SERVICE BULLETIN SB99.9C

Machines/Models: LX31,41,50 European with Outriggers

Serial Numbers:
2747 to 2965

PURPOSE: To enhance operation of limit switch during outrigger operation.

Figure 2

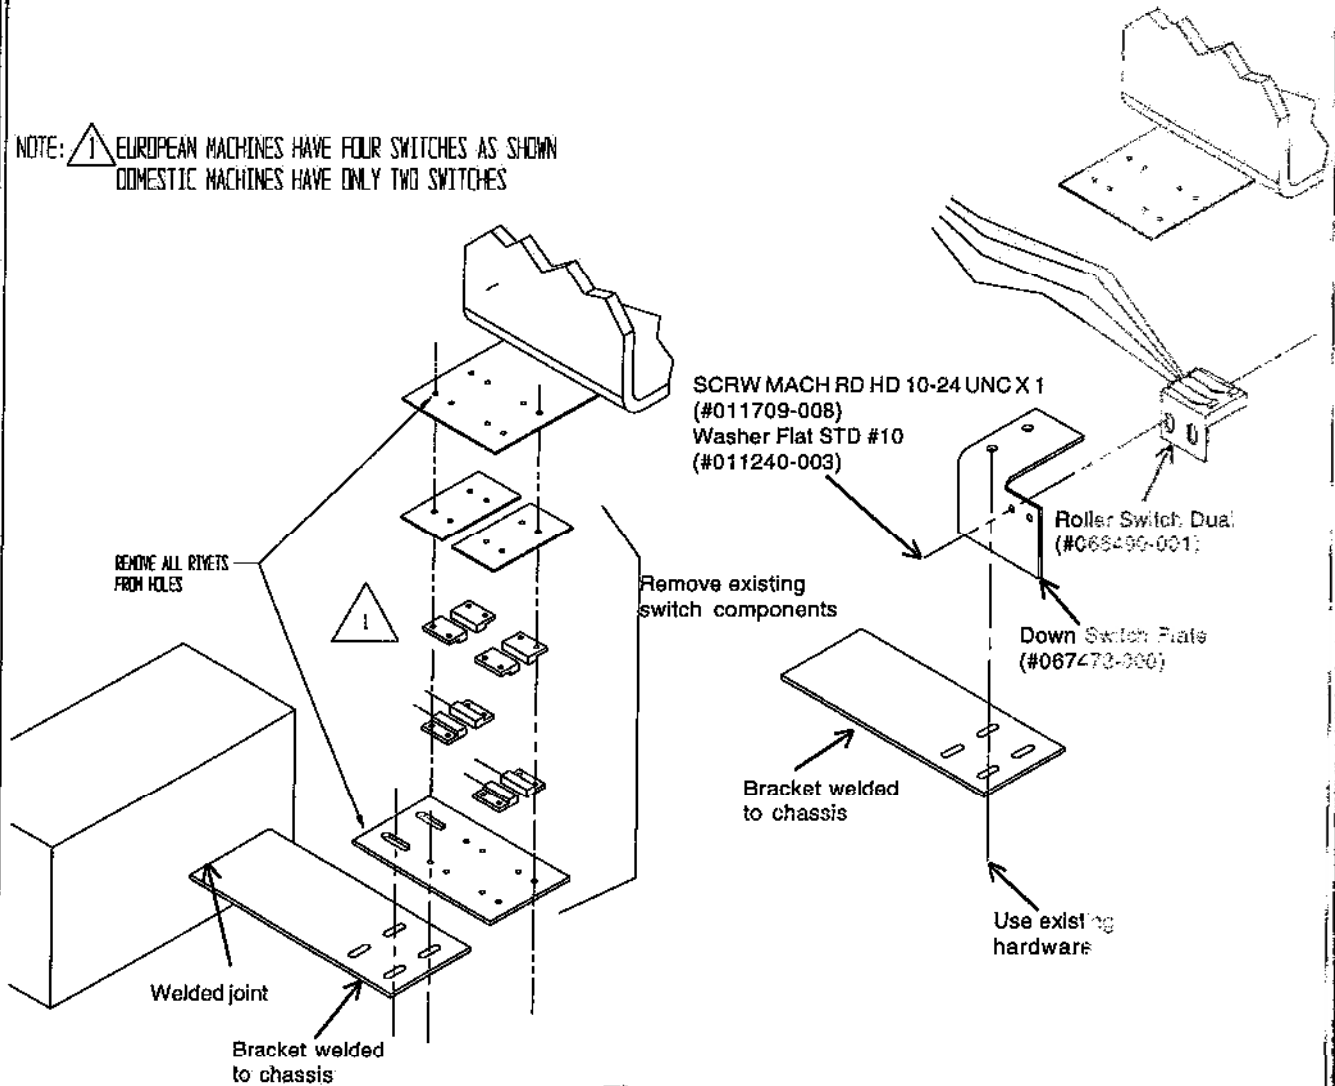
1. Remove battery negative cable from battery.
2. Locate the platform down white proximity switches at right front corner of machine under linkage.
3. Remove the existing white proximity switches, rivets and shim plates. See Figure 2.
4. Cut off 3-Conductor Cable from switches. Butt connect the middle two black wires together. Butt connect the white and black wires from the 3-Conductor Cable and attach them to one of the switch black lead wires. Butt the other switch black wire to the red wire of the 3-Conductor Cable.
5. Attach Roller Switch Dual (#066490-001) and Platform Down Bracket (#067473-000) as shown in Figure 2.
6. Adjust Roller Switch Dual (#066490-001) so machine goes into "creep speed" before platform height reaches 9 ft. Tested "creep speed" should be 18-22 sec. for machine to travel 20 ft.

NOTE:  EUROPEAN MACHINES HAVE FOUR SWITCHES AS SHOWN
DOMESTIC MACHINES HAVE ONLY TWO SWITCHES

OPERATION REQUIRED: Replace existing white proximity switch with roller type.
